Re: Large Noncoal Mine Application Maggie Lynn Underground Mine SMP Application No. 63192001 NPDES Permit Application No. PA0278360 Deemston Borough, Washington County

The Department has reviewed the applicant's submittal dated July 21, 2024 from GeoTech Engineering, Inc. (GEI) in response to the Department's June 26, 2024 comment letter regarding the above-referenced large underground noncoal (LNC) permit application. In order to continue processing the permit applications the following additions, corrections, and clarifications must be made. All regulatory references below are from Pennsylvania Code Title 25. Environmental Protection unless noted.

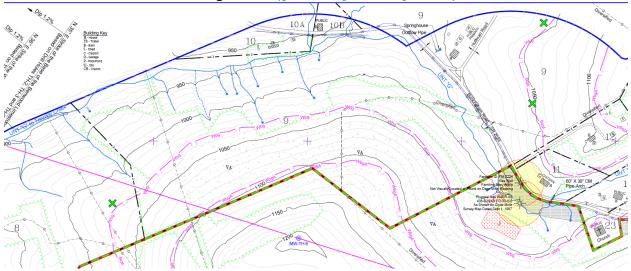
4. At the August 26, 2024 public meeting, a resident expressed concern regarding unmapped wetlands and potential impacts to wetlands. After this meeting, the Department identified three areas of potential wetlands located on Properties 8 and 9 within the 1,000-foot offset line along the Waynesburg Coal horizon. These wetlands must be visually identified and surveyed in the field and shown on Exhibits 6.2, 9, 15.2, 16.17, and 18 using the green wetland symbology. These additional wetlands need not be lettered, nor formally delineated since they do not lie within the permit boundary and therefore no revisions to Module 14 are necessary. See the map below for potential wetland locations marked with a green X. (§77.104, §77.410, §77.454)
